**Subject:** The change of fore arm part externals of RV-13F(L)

**Applicable to:** RV-13F(L) series

Figure 1 Details of the design change

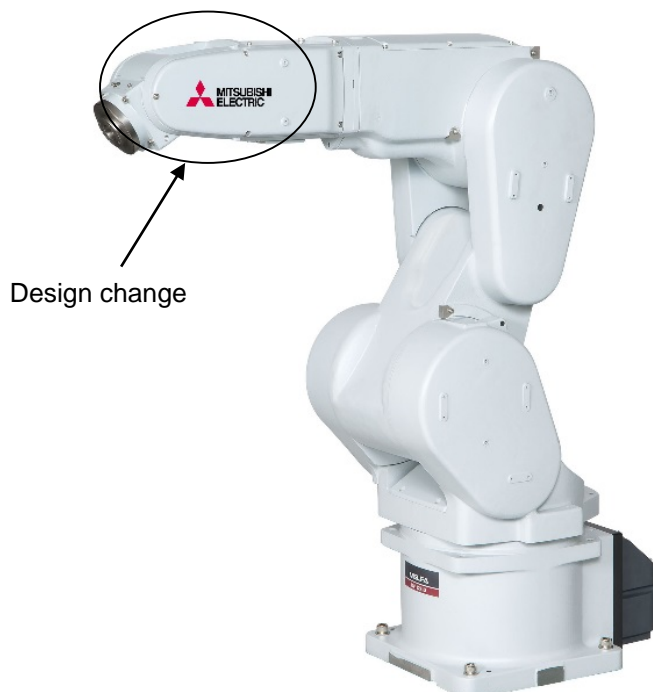
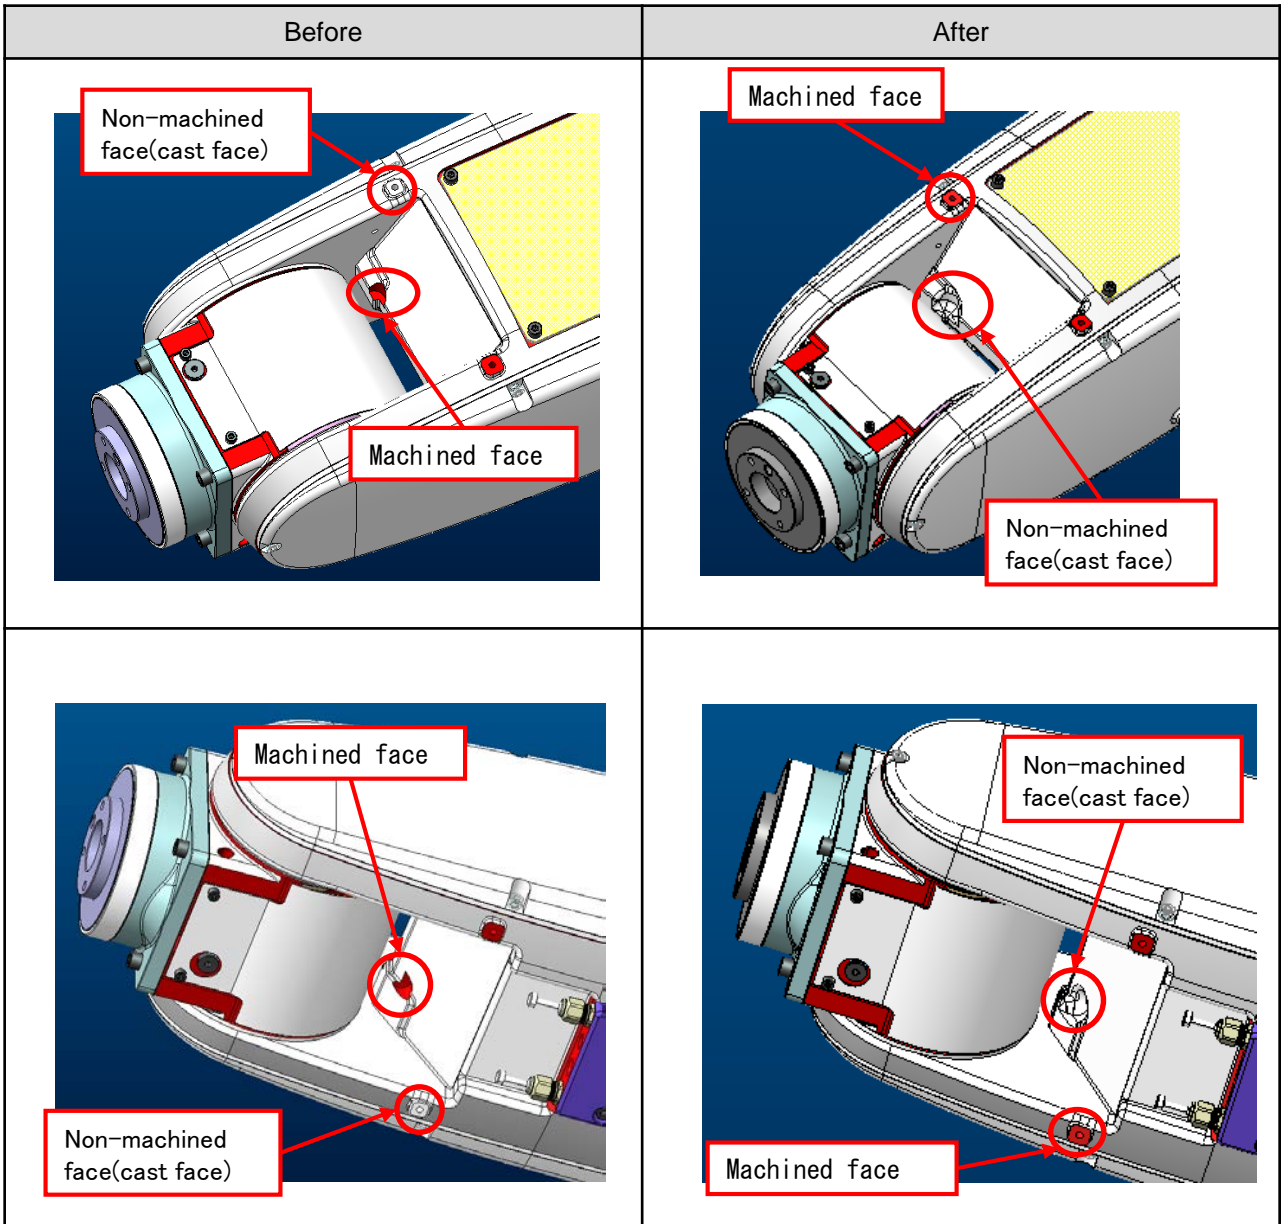
The design of the fore arm part is changed.

By this change, there is no influence of the function and performance on a robot.

**3. Reason for change**

For productivity improvement.
